DART SERVICE INSTRUCTION

TO AMEND INSTALLATION INSTRUCTIONS IIN-D407-781-2 REV. A OR LATER APPROVED REVISION
AND INSTRUCTIONS FOR CONTINUED AIRWORTHINESS ICA-D407-781 REV. 3 OR LATER REVISION

A	NEW ISSUE		13.04.08
REV.		DESCRIPTION	BY DATE
DESIGN			
DRAWN			
CHECKED			
MFG. APPR.	N/A		
APPROVED			
DE APPR.			
DATE	13.04.08		
		DART AEROSPACE LTD HAWKESBURY, ONTARIO, CANADA	
		DRAWING NO. REV. A DSI 9649 SHEET 1 OF 2	
		TITLE SCALE ALTERNATE INSTALL NTS	
COPYRIGHT © 2013 BY DART AEROSPACE LTD. THIS DOCUMENT IS PRIVATE AND CONFIDENTIAL AND IS SUPPLIED ON THE EXPRESS CONDITION THAT IT IS NOT TO BE USED FOR ANY PURPOSE OR COPIED OR COMMUNICATED TO ANY OTHER PERSON WITHOUT WRITTEN PERMISSION FROM DART AEROSPACE LTD.

**FIGURE 1 - D3879-1 BAGGAGE COMPARTMENT WALL
PROTECTOR - ALTERNATE INSTALLATION**

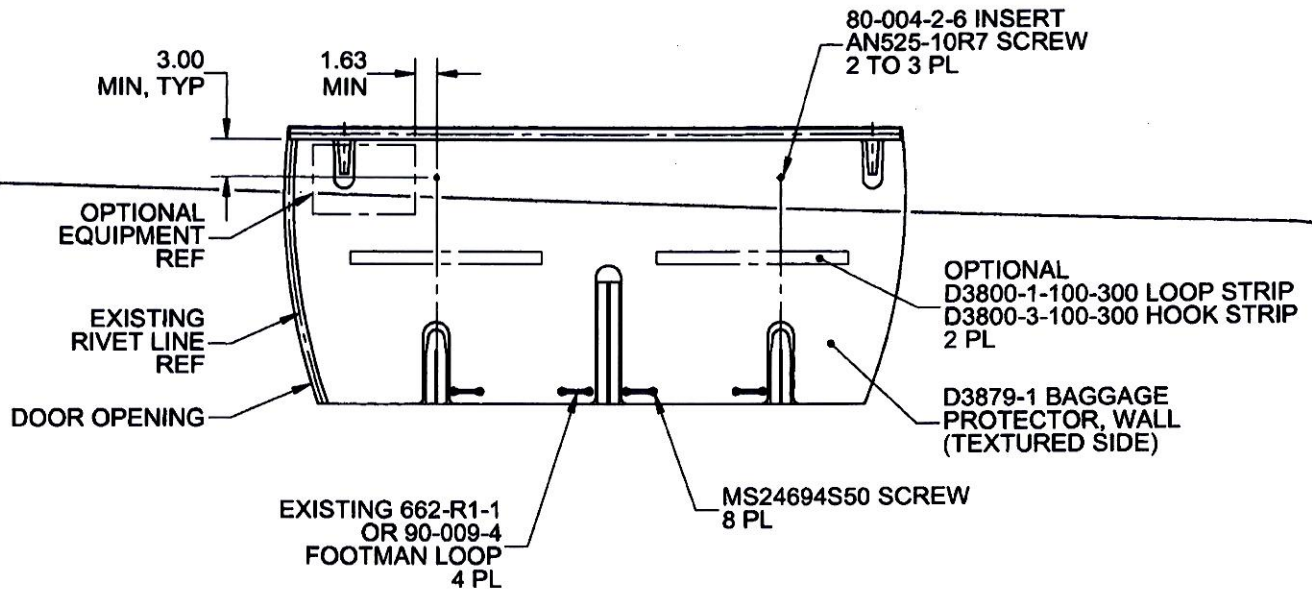
In some aircraft, the top portion of the D206-781-041 Baggage Compartment Wall Protector Kit cannot be installed as indicated in IIN-D407-781-2. The purpose of this DSI is to provide an alternate mounting method to fasten the top portion of the D206-781-041 Baggage Compartment Wall Protector Kit.

It is acceptable to replace qty(2) D3930-1 Clips with qty(2) 80-004-2-6 Inserts. Locate and mark location of the two attachment holes on the baggage compartment wall as shown in Figure 1 of this service instruction. Install 80-004-2-6 Inserts at the marked locations in accordance with Section 3-2-12 of BHT-206-SRM-1. It is acceptable to trim the wall protectors to accommodate optional equipment or transfer attachment holes to the wall protector and install the optional equipment on top of the wall protector with longer fasteners.

Amend the D206-781-041 Baggage Compartment Wall Protector Kit parts list as follows:

ADD:

Qty -061	Qty -031	Qty -041	Part Number	Description
X			D206-781-061	BAGGAGE COMPARTMENT PROTECTOR KIT (FLOOR AND WALL)
1	X		D206-781-031	BAGGAGE COMPARTMENT FLOOR PROTECTOR KIT
1		X	D206-781-041	BAGGAGE COMPARTMENT WALL PROTECTOR KIT
		2	AN525-10R7	SCREW
		2	80-004-2-6	INSERT
